# Bridging Design Excellence Strategy

Mixed use development with in-fill  
affordable housing

57-61 Archer Street and 34 Albert Avenue, Chatswood

Revision	Revision date	Status	Authorised: Name & Signature
V1	26 July 2024	DRAFT for GANSW review	Ian Cady 
V2	19 August 2024	DRAFT 2 for GANSW review	Ian Cady 
V3	6 November 2024	DIP Addendum draft	Amanda Harvey

**Figure 6 Revised through site link**  
 Source: Arcadia and Woods Bagot

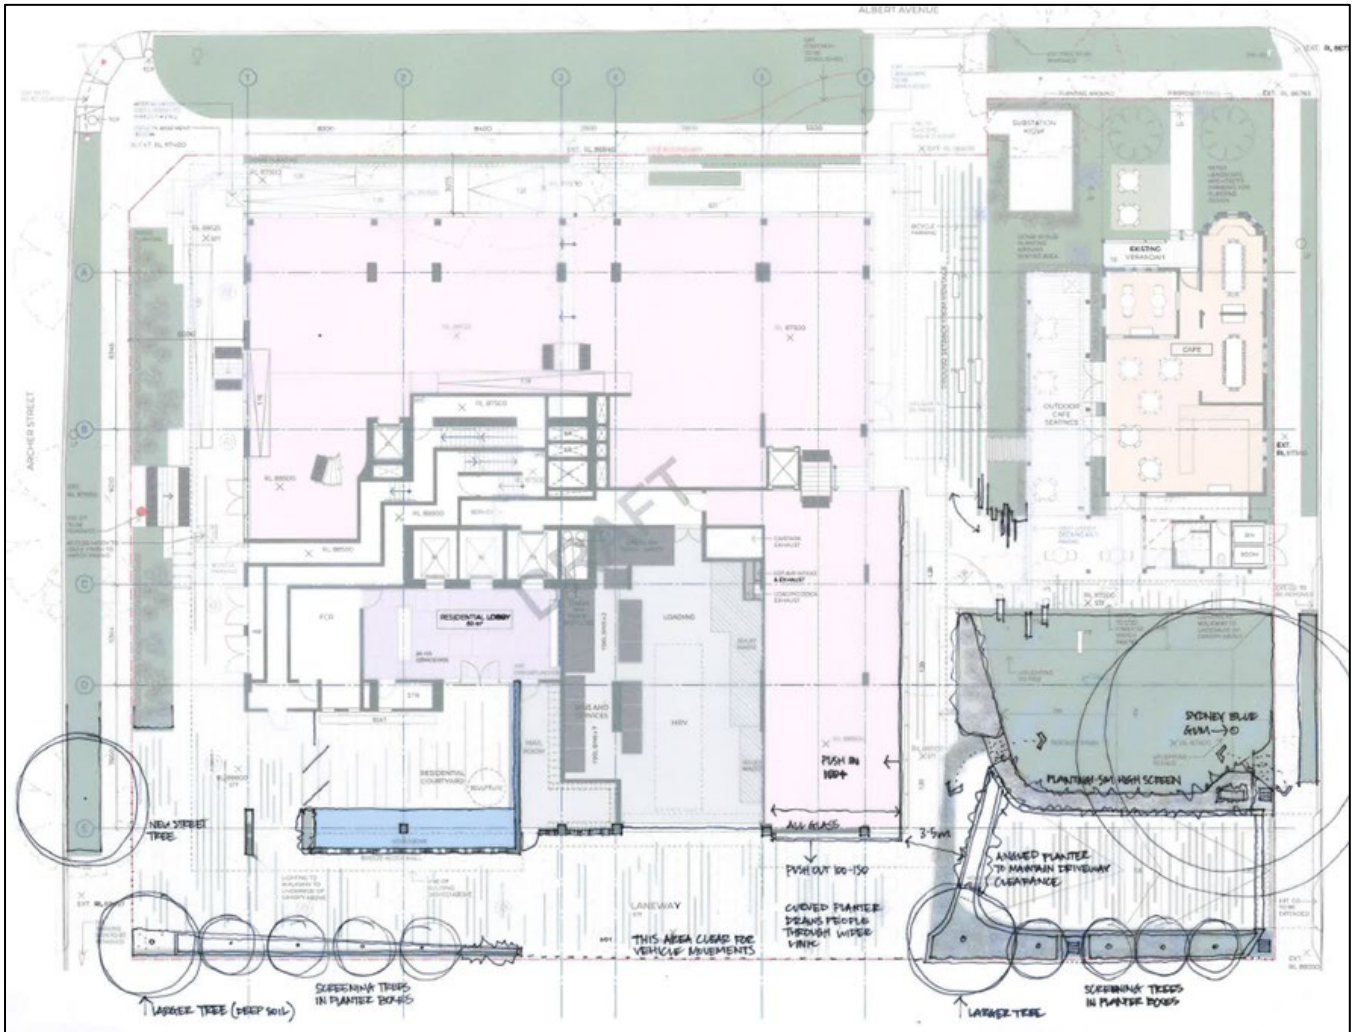
- *The Panel recommends the design team:*
  - *reconsider the alignment, geometry (and width if possible) of the carpark entry to provide a visually clear, physically linear, and direct public connection between Archer Street and Bertram Street. This should be at least 2m in width to improve way-finding and CPTED outcomes for pedestrians using the shared-way.*

- *the provision of deep soil to support increased planting and tree canopy coverage.*

**Response provided:** Woods Bagot and Arcadia have identified a number of design refinements to improve the visual and physical connectivity and landscape character of the through site link, as indicated in the following sketch.

The proposed car park entry ramp has been carefully positioned to:

- Minimise vehicle movements via the through site link.
- Separate service vehicles and cars.
- Allow for safe vehicular movements in and out of the basement carpark.
- Maintain sufficient headroom for cars at level B1 and B2.
- Maximise the deep soil provision for the pocket park.
- Provide for stormwater drainage from the site to the south.
- Provide level and equitable pedestrian access throughout the through site link.
